BULLETIN
From Atari Customer Service

B-0058
Date: June 20, 1979

MODIFICATION OF AUTOMATIC ROM/RAM TESTER FOR NEW STYLE ROMS

Illustration 1

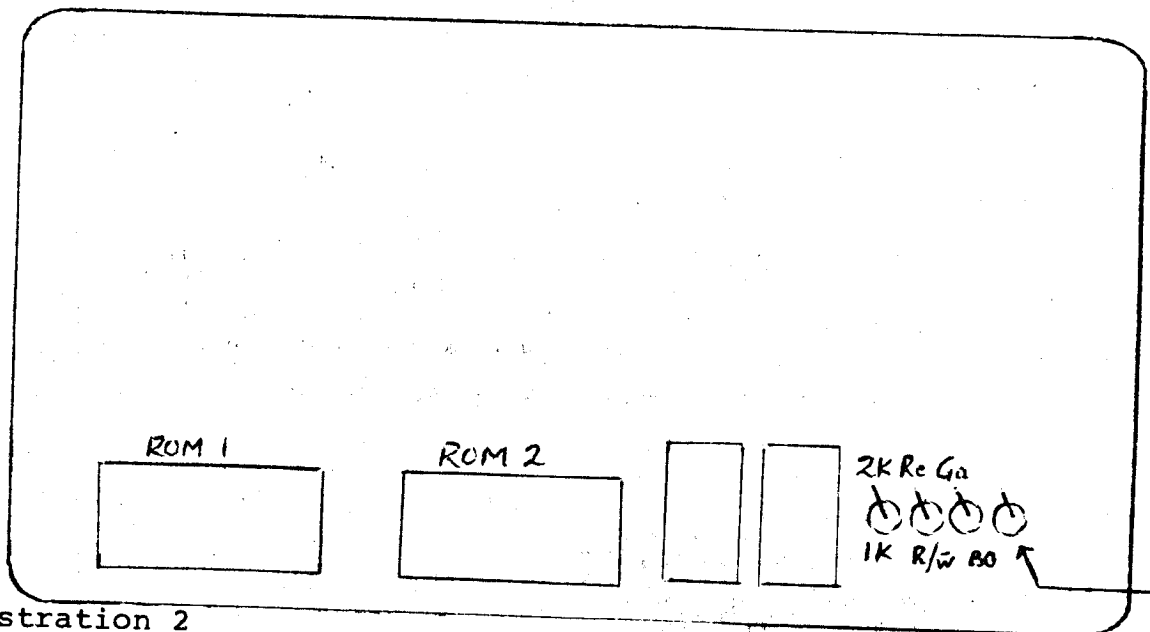
Dismantle the test unit by separating chassis from P.C. board and prepare to mount the new switch. The switch is to be placed in the lower right hand corner adjacent to Game/Box switch (see Illustration 1).

Illustration 2

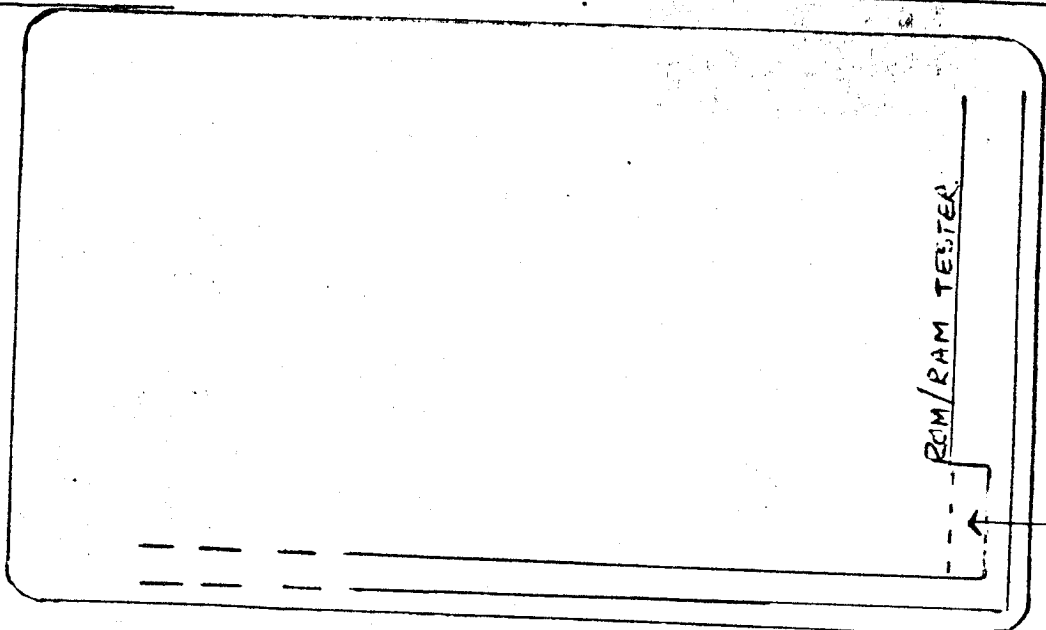
Before drilling the P.C. board, it is necessary to remove a section of the ground trace (see Illustration 2) to prevent any short circuit conditions. Use your Exacto knife for this. Now drill the 3 holes for the switch terminals, using a 7/64" drill bit. The holes do not have to be as precise, but make sure that when you put the board up to the chassis, the switch fits into the holes without any bending. Now epoxy the switch bottom to the P.C. board.
